To: INCITS T10 Committee
 From: Paul Entzel, Quantum
 Date: 8 May 2006
 Document: T10/06-236r0
 Subject: FCP-4 Fix race condition between REC ACC and FCP_XFER_RDY

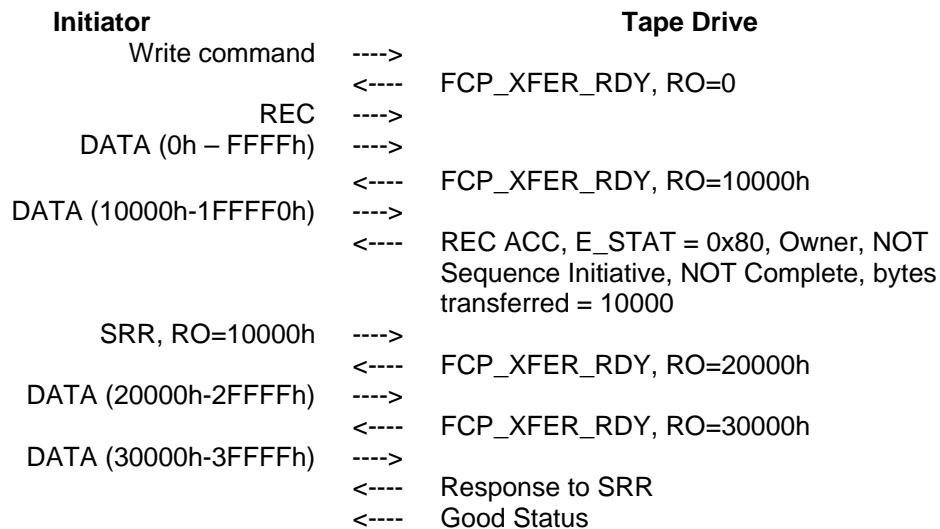
In Figure C.5 there is a paragraph that appears to have been included to deal with a race condition between the ACC for a REC and a FCP_XFER_RDY. The paragraph states:

"Wait REC_TOV*. If FCP_XFER_RDY is returned, continue with the Exchange. (ACC to REC arrived before FCP_XFER_RDY, out of order). Otherwise continue recovery."

The diagram shows this wait period beginning at the receipt of the ACC for an REC.

Recently, we have experienced a problem that is similar to this in a Fibre Channel tape drive that was performing extended recovery operations on the medium during a write operation. The buffer filled and a new write command was sent when there was no room in the buffer for the data associated with the command. The HBA polled with an REC every few seconds until at last there was room in the buffer. The REC and the FCP_XFER_RDY were timed so closely that they may have actually passed each other in the Fibre. Here is a ladder diagram of the condition:

This isn't exactly covered by the text in table C.5, since the FCP_XFER_RDY was received by the initiator port before the ACC for the REC, not after. The HBA has not violated the standard since there is no requirement in the normative part of the standard governing this case. However, the problem could have been avoided had the HBA ignored the REC ACC payload and not performed a retry based on the fact that it had received traffic for the exchange in question since it had sent the REC. This proposal will

attempt to correct this condition by adding requirements within the normative clauses in FCP-4 to cover the case already described in table C.5 and expanding it to cover the case described by the ladder diagram above.

If the ACC for an REC indicates that an FCP_XFER_RDY IU was sent by the target FCP_Port (i.e., by indicating that the initiator FCP_Port holds Sequence Initiative, that all bytes were not transferred, and that the Exchange is not complete), but not received by the initiator FCP_Port, the initiator FCP_Port shall issue an SRR in a new Exchange to request retransmission of the FCP_XFER_RDY IU. [To avoid race conditions between the ACC for an REC and an FCP_XFER_RDY IU, the initiator FCP_Port shall wait REC_TOV after receiving the ACC for an REC before sending an SRR to recover for a lost FCP_XFER_RDY IU. If the initiator FCP_Port receives an FCP_XFER_RDY IU for an exchange after sending an REC or within REC_TOV time after receiving an ACC for an REC, it shall continue normal processing of the FCP I/O operation for that exchange and ignore the contents of the ACC.](#)
